BEECHCRAFT Bonanza 35

SERVICE BULLETIN

TITLE: PLACARDS AND MARKINGS - INSTALLATION OF FUEL SELECTOR PLACARD

SB No. 2670

Figure 1

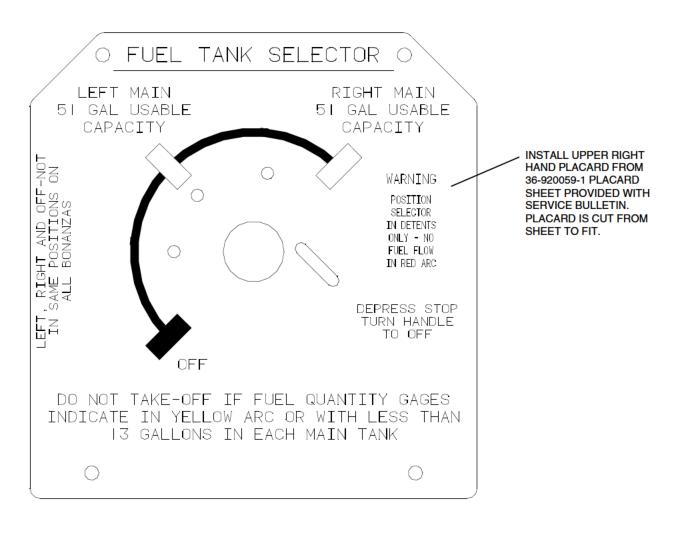
- (1) Figures 1 and 2 (and matching placards attached) are to be used primarily for the serials shown but may be used as an example of suitable configurations for typical Beech single-engine and twinengine Beech airplanes. The no-flow sectors include the areas between tank detents and any "OFF" selection. Ensure that the placard does not cover any existing words or markings.
